**207 Goldhurst Terrace
London NW6 3ER**

**Basement Impact Assessment
Audit**

London Borough of Camden

Project Number: 12066-47
Revision: F1

Basement Plan Showing Proposed Underpinning. (Scale 1:50 at A1).

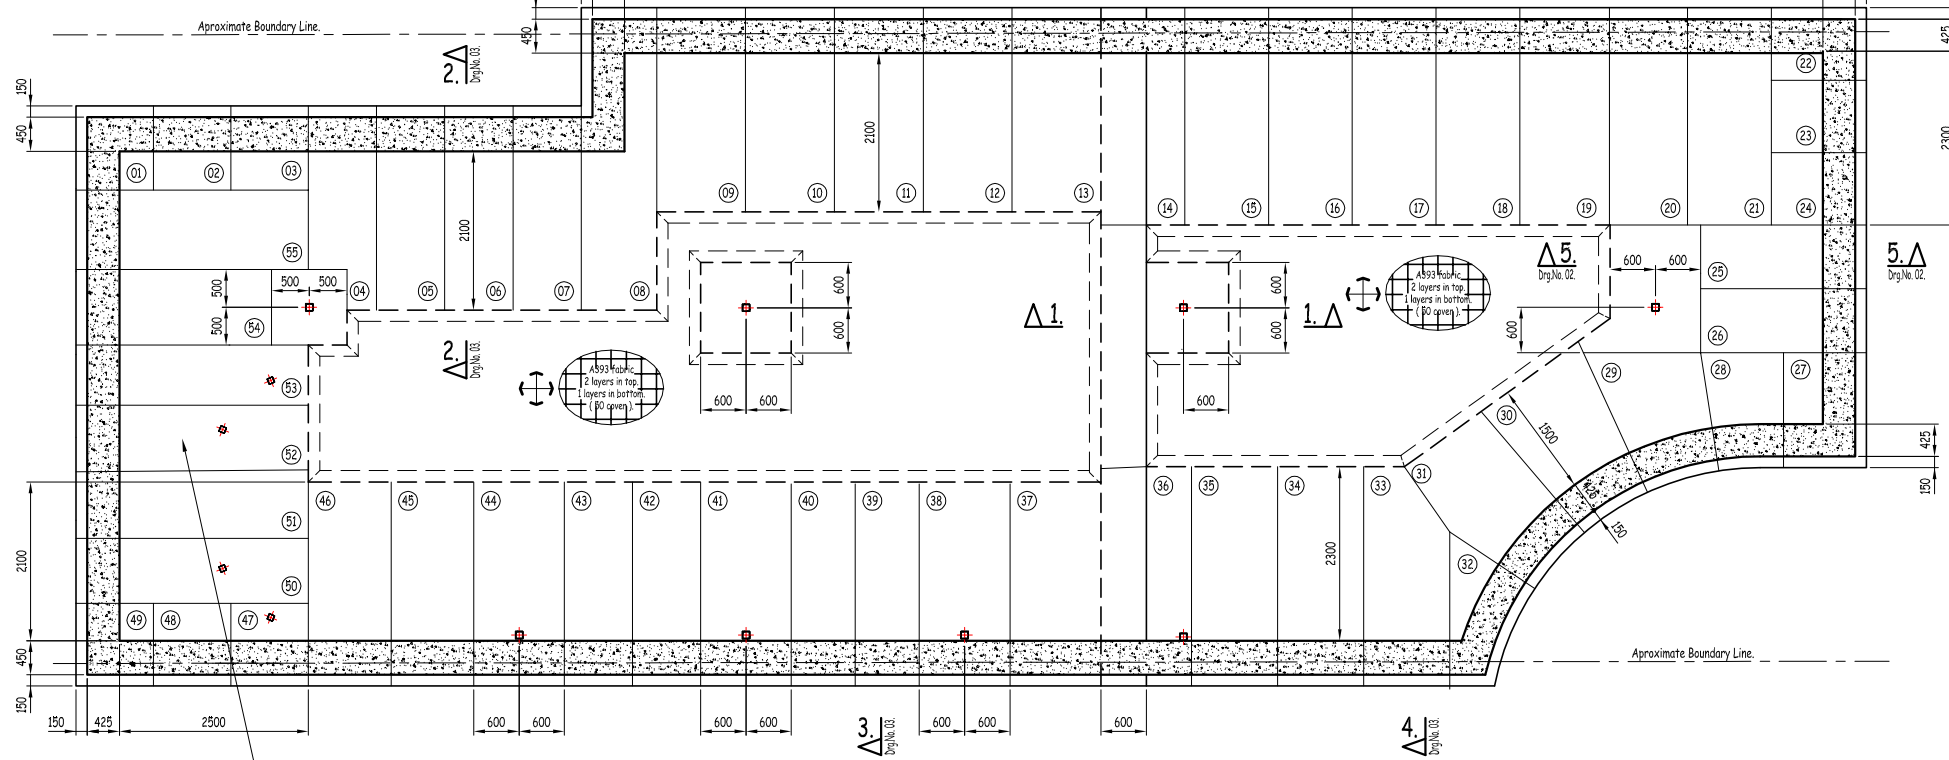
- 4.11. The structural calculations for the retaining wall indicate a 400 deep base and the original drawings indicated a 350mm deep base. This is now updated to 400mm as per the calculations.

CAMDEN GEOLOGY – Extract from FIGURE 4 Camden Geological, Hydrogeological and Hydrological Study

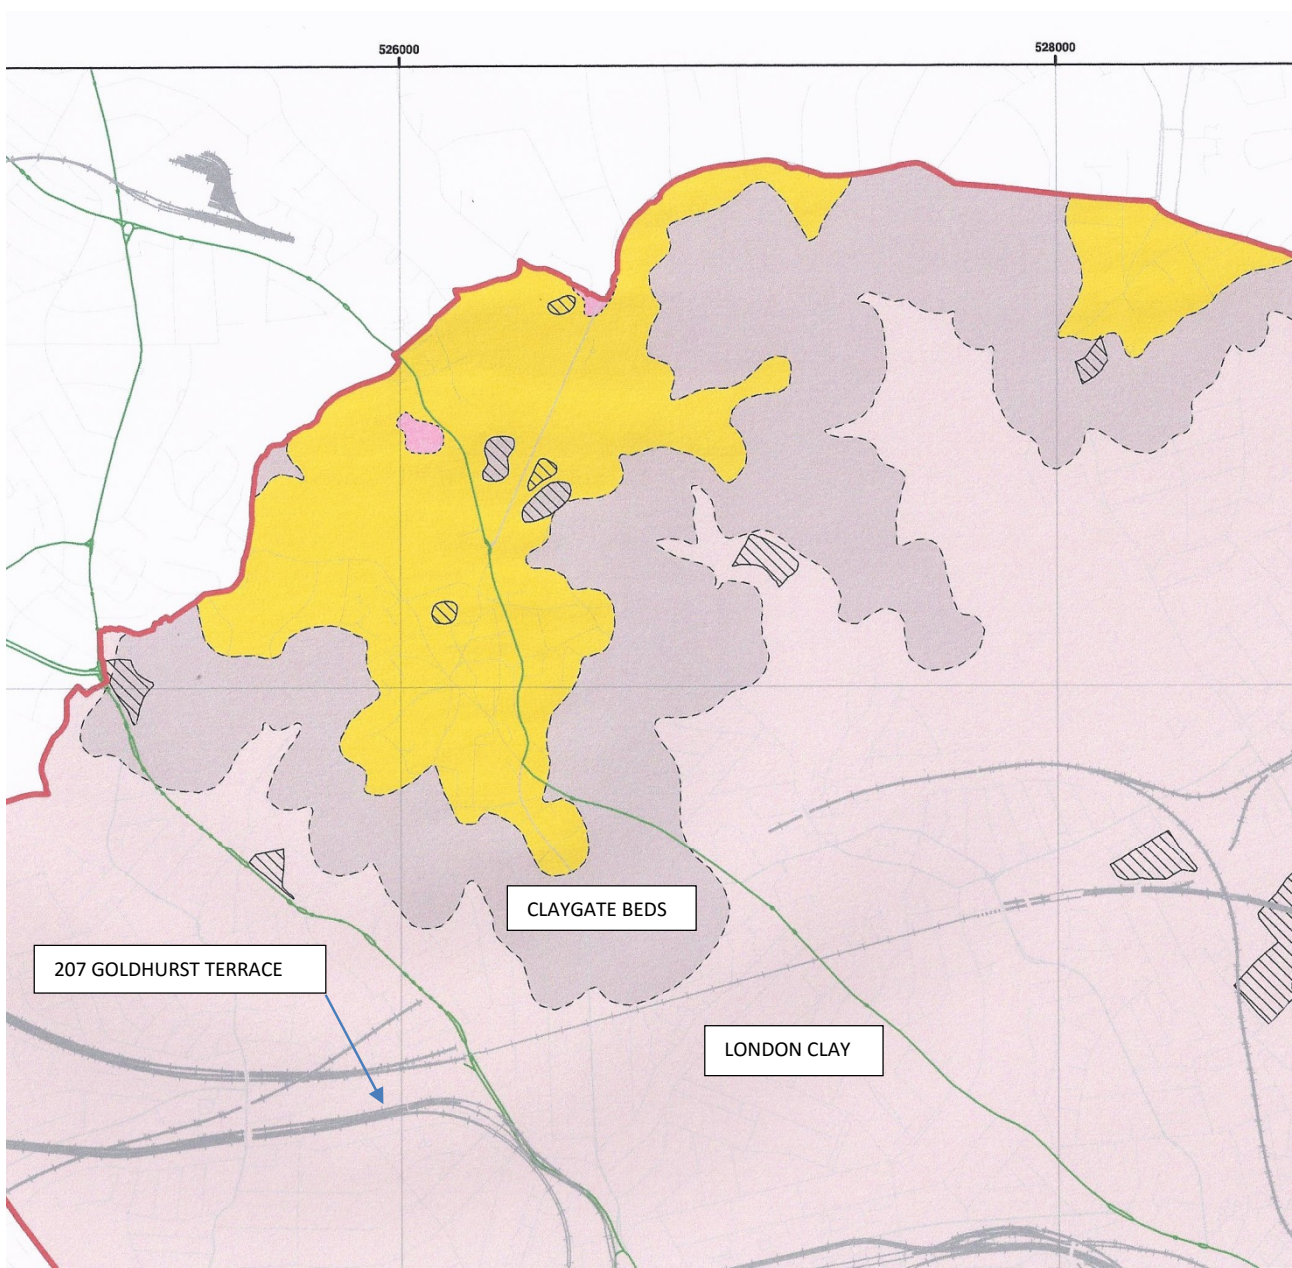
- 4.3. The BIA makes reference to Camden GSD maps and guidance documents used for the screening, we would expect the relevant figures to be included to justify the statements given within this section. The updated BIA only contains an extract from Fig 4 from the GSD which identified the sites.

6	Scoping	Provide site specific extracts from GSD figures justifying stage 1 scoping	Not addressed in new documents - the screening process described in CPG4 appears to have been followed, however the figures mentioned are not contained in the BIA to support the findings. For example the BIA contains only Figure 4 (geological map) which appears to reference a site at Kidderpore Gardens?
7	Stability	Provide amended calculation for retaining wall	Previous calculations are presented still discrepancies with drawing: <ul style="list-style-type: none"> Depth of concrete base to wall 350/400 ? Concrete cover to stem reinf 50/75 ? passive pressure/soil properties not as per ground investigation report recommendations
8	Stability	Provide construction sequence plans and develop Construction Method Statement. Resolve discrepancies between BIA and CSM	Structural Design Philosophy and Construction Sequence contained within BIA - will consider this as acceptable

Query 6 - The Figure 4 geological map makes reference to Goldhurst Terrace not Kiddapore Gardens, the figure supports the findings.
